DAR topics

previous DAR comments | challenges

building footprint | open space

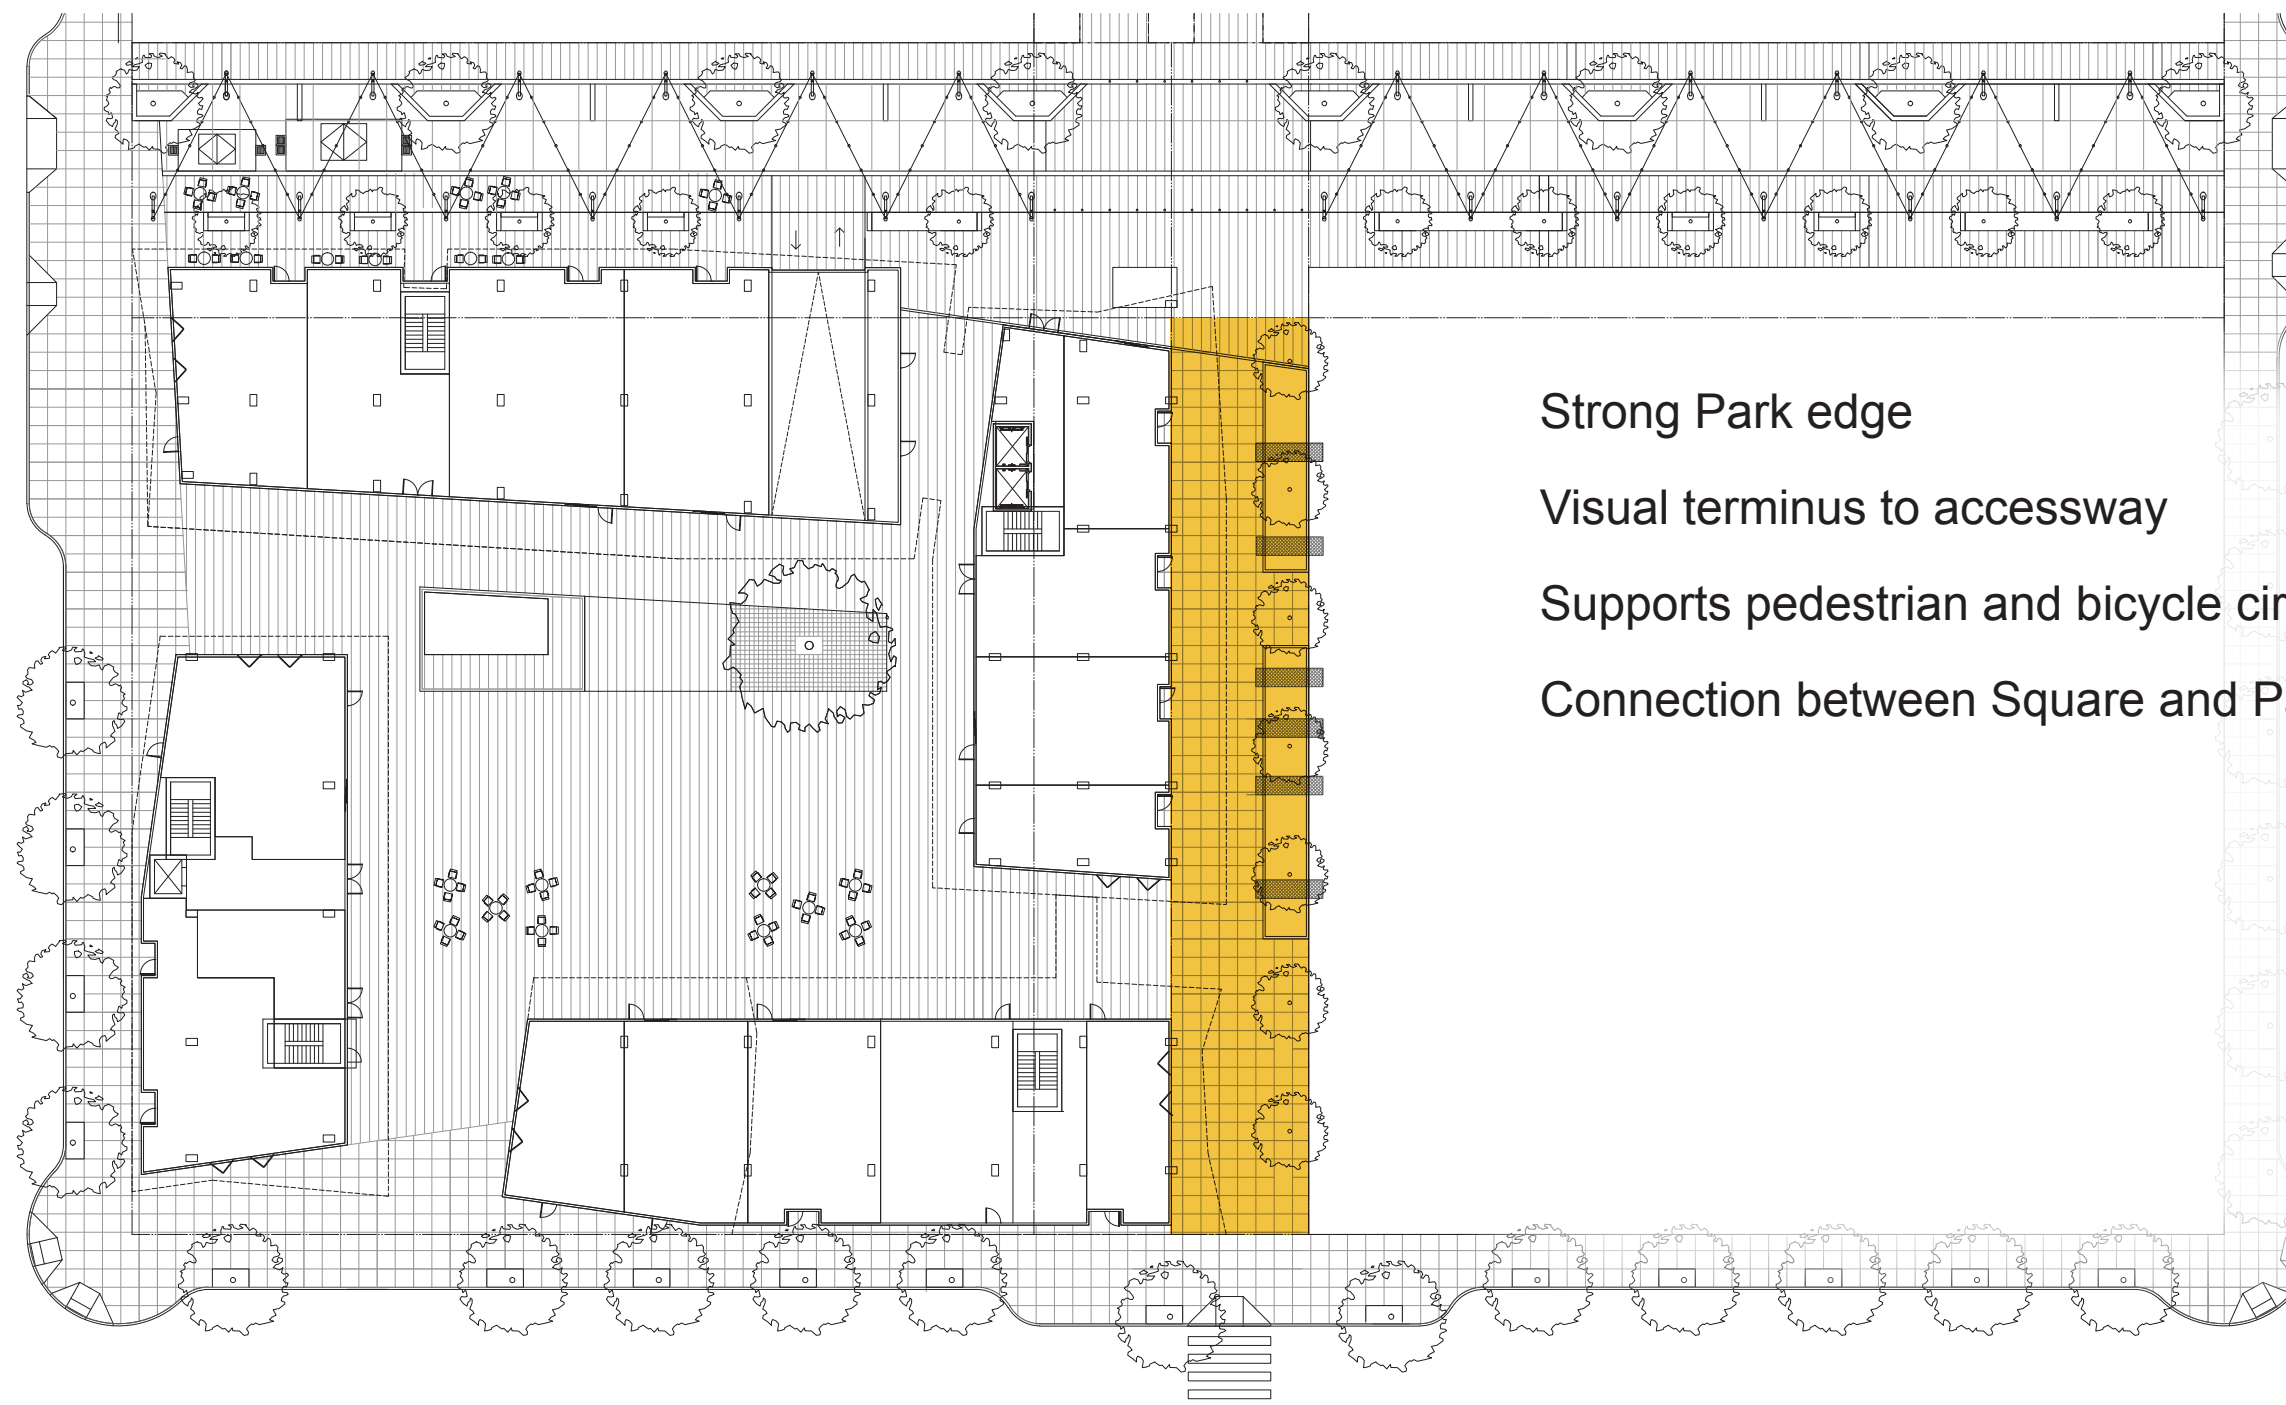
1. Footprint - Adequate square size, strong connection to the park and accessway

- Strong Park edge
- Visual terminus to accessway
- Supports pedestrian and bicycle circulation
- Connection between Square and Park

neighborhood square design

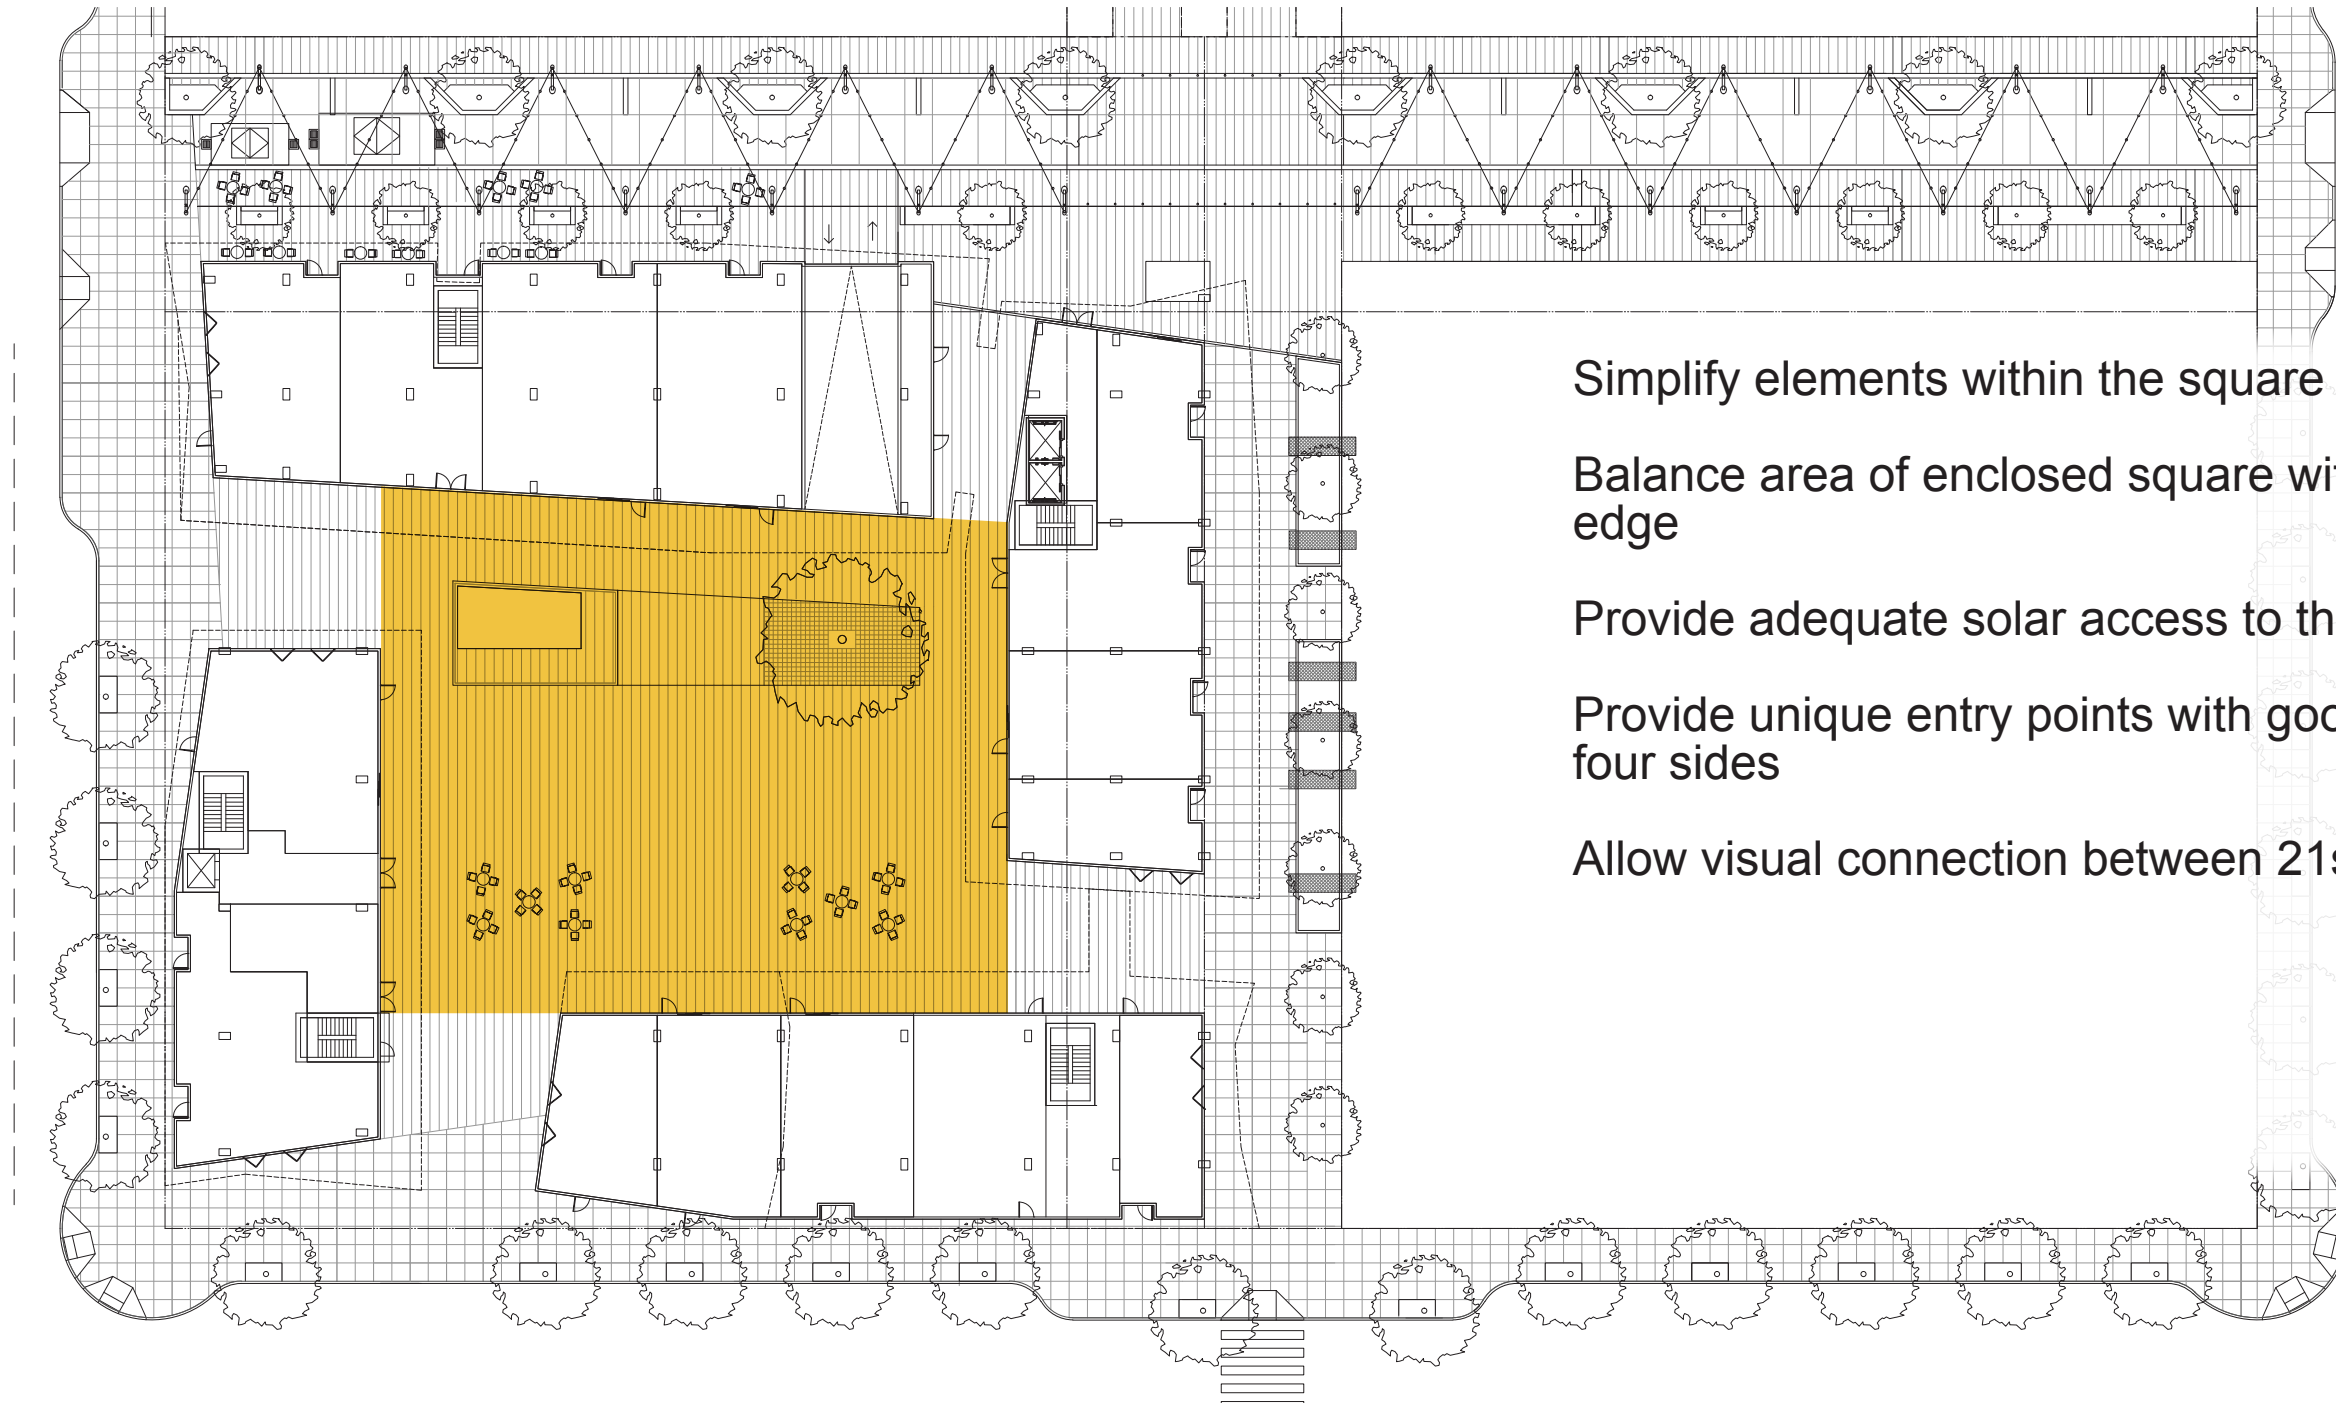
2. Square - versatile, active and iconic

Simplify elements within the square

Balance area of enclosed square with pedestrian path along park edge

Provide adequate solar access to the square

Provide unique entry points with good visibility to the square on all four sides

Allow visual connection between 21st Avenue and the park

building heights

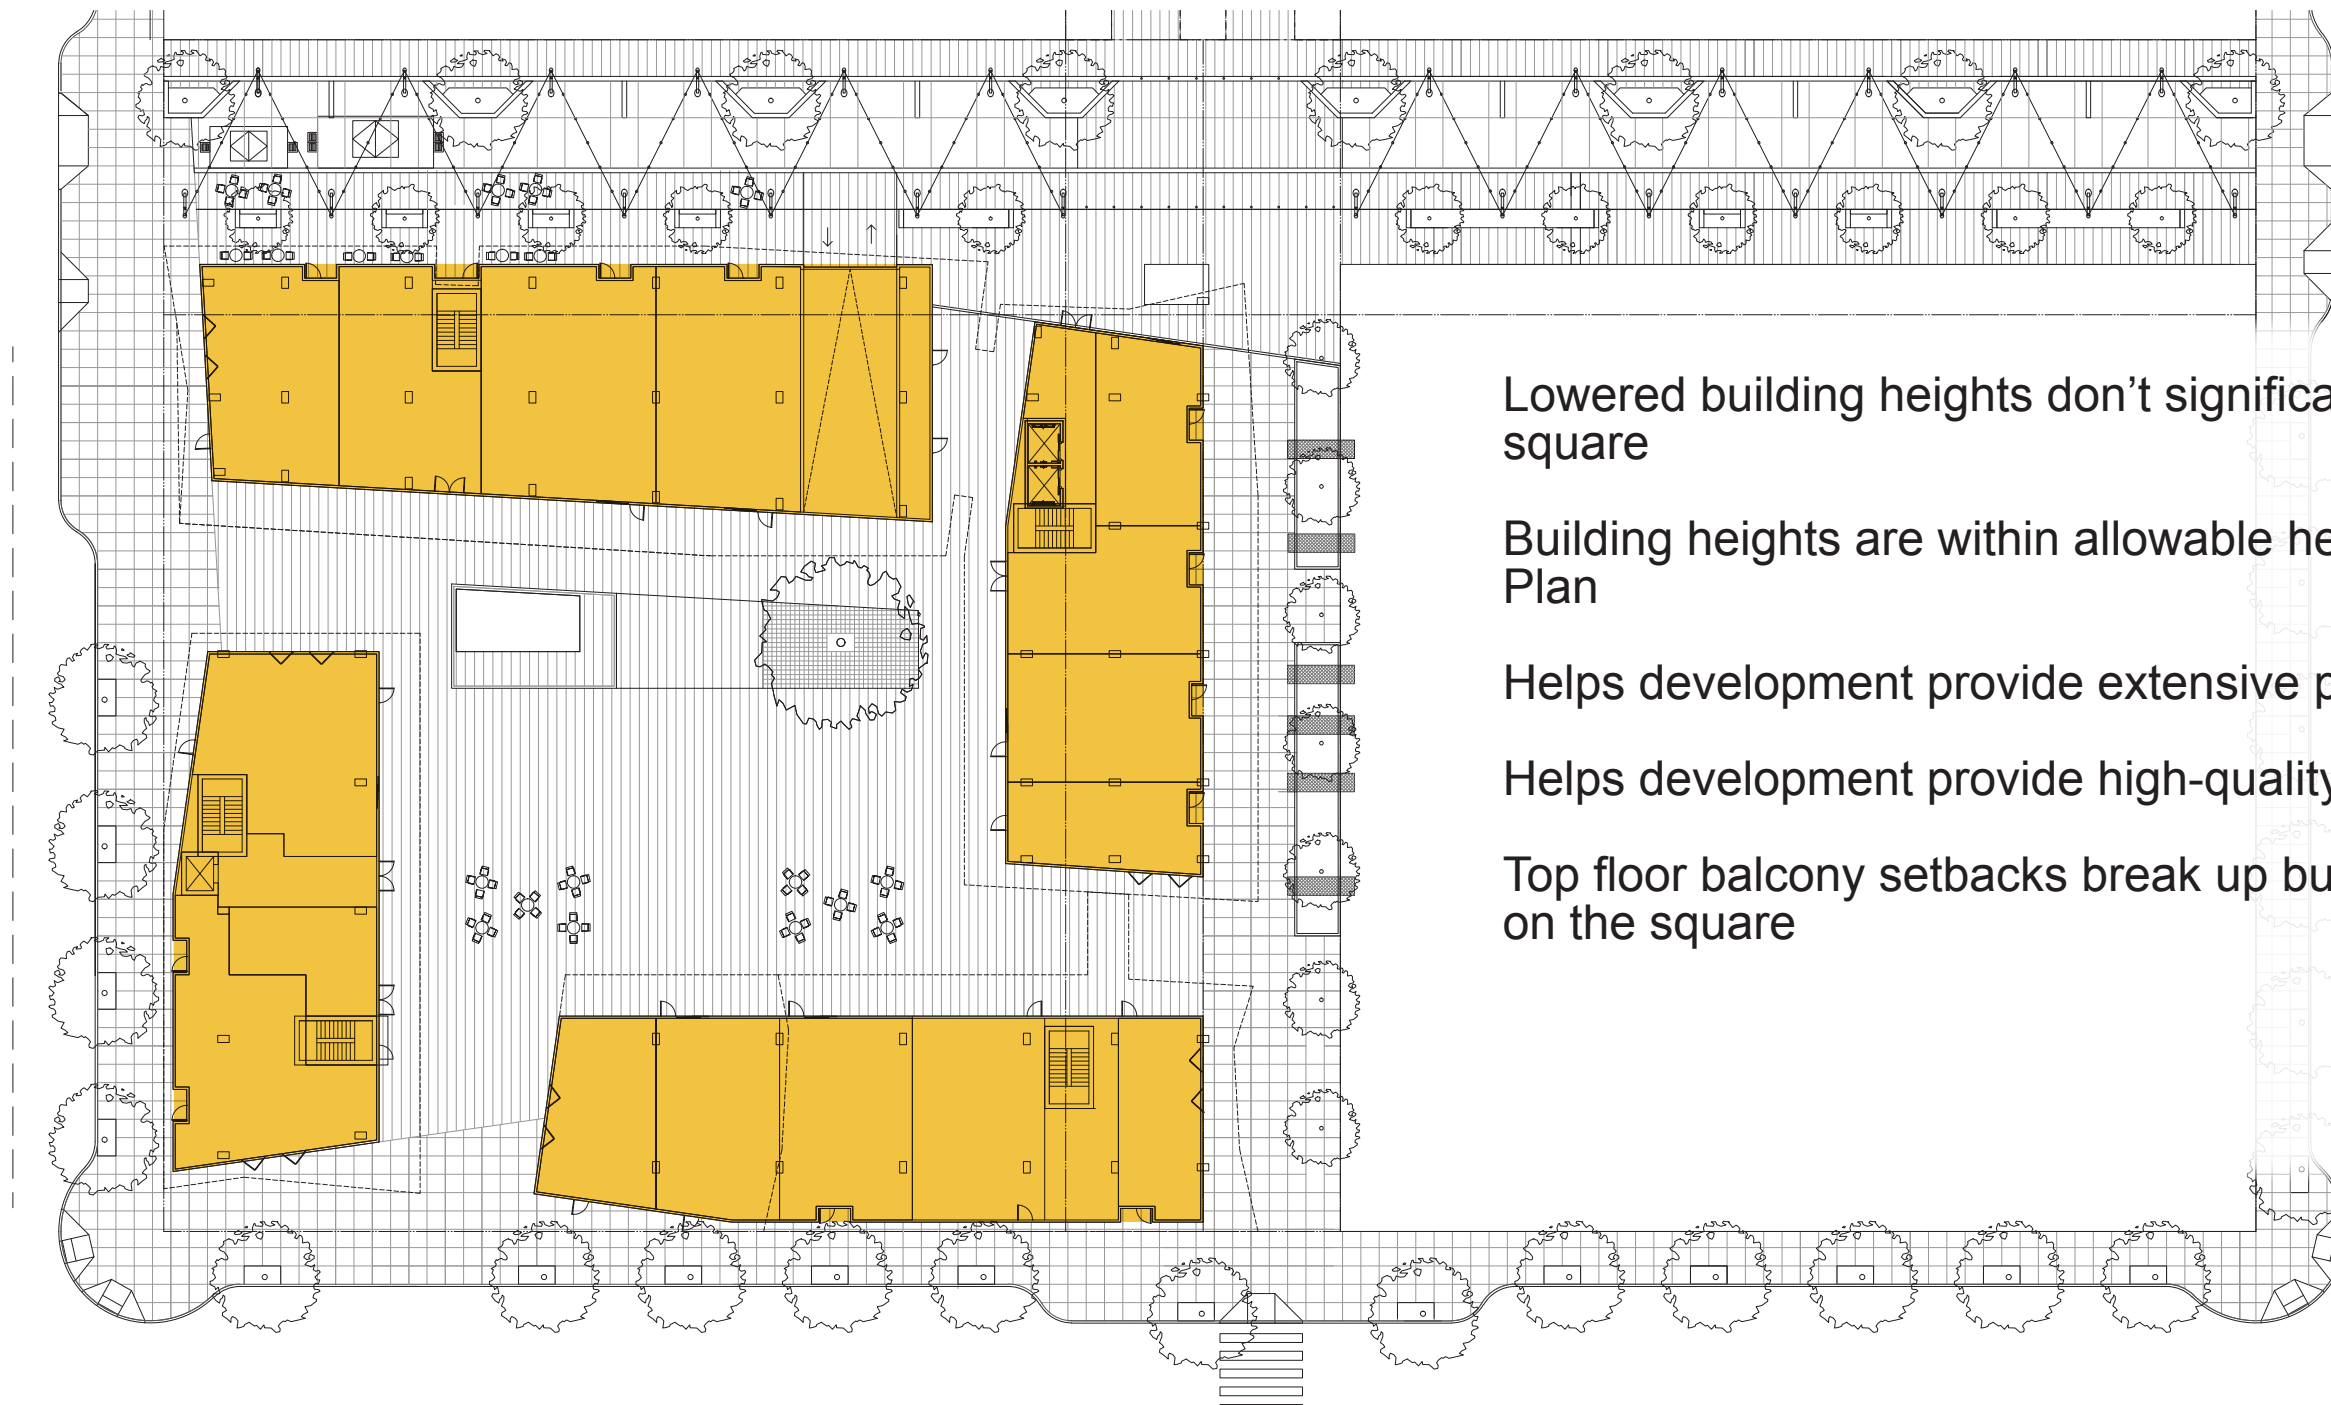
3. Heights - Good solar access

Lowered building heights don't significantly alter solar access to the square

Building heights are within allowable heights per the NW Master Plan

Helps development provide extensive public amenities

Helps development provide high-quality materials

Top floor balcony setbacks break up building scale and provide eyes on the square
